INDESIT company

Model type:
CDE12X

Commercial code:
F027226

Notices

Fig. 1

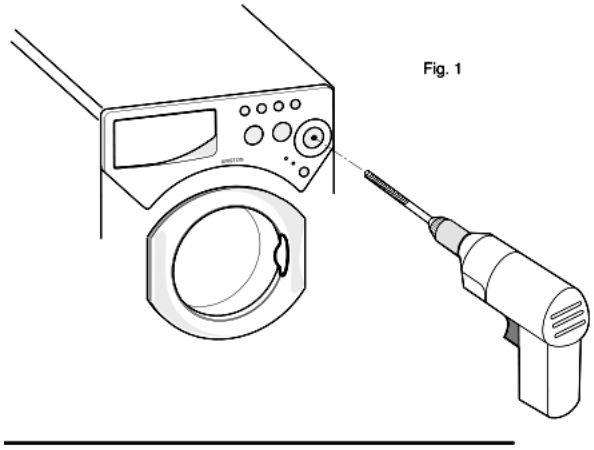
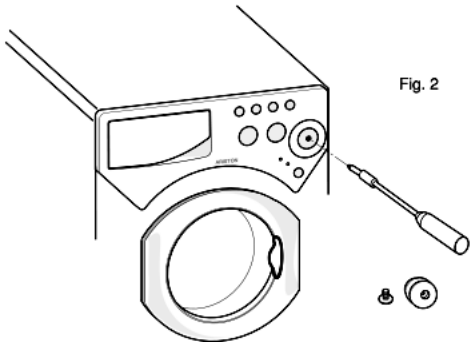
n1040241: Indivisible timer knob and push-push mec

From serial number 20305.0001, the component knob / selector code 084812 is provided with internal flaps, which ensure a perfect assembly of the knob and push-push mechanism on the built-in washing machines. This prevents the knob from coming off when the plastic material becomes soft due to temperature increasing inside the appliance during the drying phase.

To remove the selector knob, proceed exclusively as follows:
1) Using a drill with a 12 mm bit, drill a hole in the centre of the knob (see fig. 1).
2) Using a cross screwdriver, loosen the screw that secures the knob to the selector (see fig. 2);
3) Extract the knob with push-push mechanism from the selector (see fig.2) .

Fit the new knob after fixing with the screw the push-push mechanism (recovered) to the selector shaft.
In the event that the old push-push mechanism cannot be reused, use the kit code 087814 that comprises the following items:

Code 084816 - Push-push mechanism;
Code 087815 - Timer screw 1/2 T4,2X12.7;
Code 047922 - Compression spring;
Code 084812 - Component knob / timer.

FIG. 1

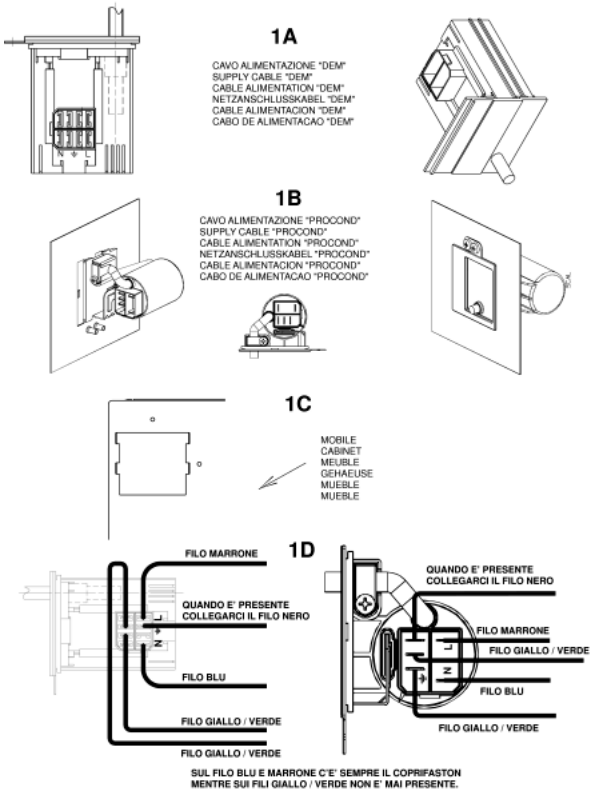
n1040276: Power supply cable + integrally moulded filter.

All appliances produced in the Comunanza (from serial no. 21008.0001), Teverola (from serial no. 21111.0001) and Brembate (from serial no. 21119.0001) factories have been equipped with power supply cables with integrally moulded filter (see fig.1 - 1A and 1B) and new units having a specific opening at the back for fixing the new cables (see fig. 1 - 1C).
The new units, together with the new cables, can be used in place of the premodification ones, by connecting the wiring to the cable, as shown in figure 1 - 1D.
The codes of the new units and of those replaced (ESI - table n1040276fig02), which will be managed until stocks run out, are given below.

IMPORTANT: the fixing / continuity screw is a specific self-scraping screw (code 092348) that ensures earth continuity between the filter and the unit. The same screw must be refitted in order to guarantee machine conformity.

The premodification wirings, are also managed for modified products by making the connection to the terminal block of the new cable as shown in fig. 1 - 1D.
The wiring diagrams given in the Documentation remain unchanged.

n1040282: New drainage OKO system.

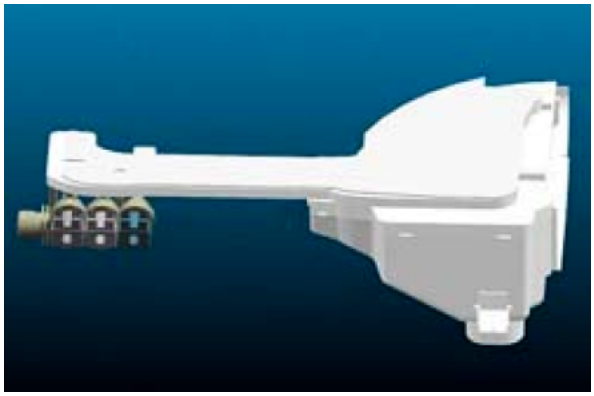
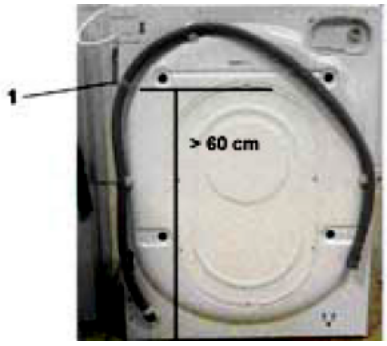
From serial number 21219.0001, the new "OKO" drainage system has been introduced on the washing machines produced in the Comunanza factory.
The last two numbers of the Industrial Code (located on the rating plate) of the models relevant to this note will be 30 (e.g. 80233560130 - see Appendix A)

- EEPROM (the OKO system requires a new setting of load timing parameters). THE NEW EEPROMS REPLACE ALL THE ONES CODED PREVIOUSLY.
- BOWL (hopper tube hole shifted forwards);
- DETERGENT LOADING TUBE (see fig. 1);
- PRESSURE SWITCH (changed levels);
- OKO PUMP BOWL BLOWER + BALL (see fig. 2A, 2B and 2C);
- CONDUCTIVITY SENSOR (if provided, it is shorter than the premodification item);
- DRAIN PUMP (without detergent collecting tube connection);
- HOPPER (shifted in front of detergent loading tube connection). Fig. 3A post-modification. Fig. 3B premodification);
- AIR TRAP (different shape);
- PRESSURE SWITCH TUBE (different length);
- DRAIN TUBE STOP (specific);

In particular, the OKO system consists of a spherical plastic component inserted in the tube that connects the bowl to the drain pump (see fig.2 A).
At the beginning of each wash cycle the washing machine fills water for 10 seconds and activates the drain pump for 2 seconds. In this way, the water level in the bowl is different from that in the drain tube; this difference increases the thrust of the ball upwards, closing the bowl-pump connection tube hermetically (see fig. 2D).
This system has the double advantage of:

1) separating the wash water and the water in the drain hose, thus saving energy during the heating phase;
2) and ensuring optimal use of all the detergent.
With the introduction of this new component, the detergent collecting tube is no longer required and the pump has one hole only to convey water from the tank.
For the correct operation of the OKO system, it is important that the drain hose of the washing machine remains fixed to the back of the unit with a plastic clamp (to this end, the clamp withstands a 25 kg load; see reference 1 in fig. 4); otherwise, the drain hose

must absolutely reach the height of the clamp. (minimum 60 cm.)

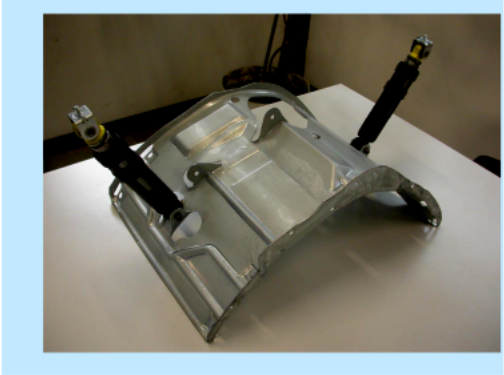
From serial no. 40427.0001, shock absorbers have been fixed to the tank unit cradle with two 11 mm pins code C00110163 (see fig. 01 and 02 enclosed) in place of the 8 mm screws code 093750 and relevant locking nuts code 030443, on all washing machines and dryers produced in the Comunanza factory.
The items affected by this modification are:

1) The cradles have the same Service code, as they can be used in place of the new ones after widening the shock absorber fixing holes to a diameter of 10 mm.
Code 093848 - Tank unit cradle 46 lt
Code 093878 - Tank unit cradle 40 lt.

2) The new shock absorbers, with fixing bushing having no s/steel spacer, are not managed as they are interchangeable with the premodified items (make sure they are CIMA type, as the managed items), fixed with M8 screws code 093750 and related locking nut code 030443 (see figs. 05 and 06).
Code 093884 - Shock absorber 80 N
Code 093885 - Shock absorber 100 N

To remove the shock absorber from the tank, first extract the pin with a few hammer taps (see fig.03) until it is aligned with the tank bracket and then pull it out with a pair of pliers (see fig. 04).
(To refit the shock absorber use a new pin. Insert the pin until the toroidal edge is aligned with the bracket.)

Fig . 001

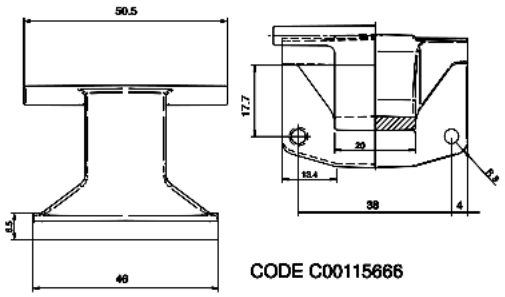
n1040371: The T4 mechanism type 4.

From serial number 30612.0001, the T4 mechanism has been introduced on some oscillating units.
The new tub units are perfectly interchangeable with the premodification ones and therefore maintain the same SAT codes.
The modification especially concerns the basket cross element and the tub cross element assembly that are specific for the new mechanism.
For servicing the products both the premodification tub cross element assembly (code 074213) and the new assembly (cod. 096077) must be managed; their use is indicated by the serial number of the relevant product.

CROSS ELEMENT ASSEMBLY AND SINGLE PARTS MANAGED AS REPLACEMENTS.
SAT code 096077 Cross element assembly with seal rings CV4;
SAT code 096186 Seal ring CV4;
SAT code 013563 Bearing 6205-2Z SKF;
SAT Code 002591 - Bearing 6204-2Z SKF;
On 1200 rpm models, which indicate replacement of the drum with spider in aluminium, with a spider in red ghisa (LVA cod. C00094280 and LVB cod. C00094282), the following pocedure will need to be followed:
1) Remove the upper counter-weight;
2) Position the balancing springs inside the support holes found further back than the previous position on the cabinet (see fig.001);
3) Affix the shock absorbers on the support holes positioned on the back part of the cabinet (see fig.002).
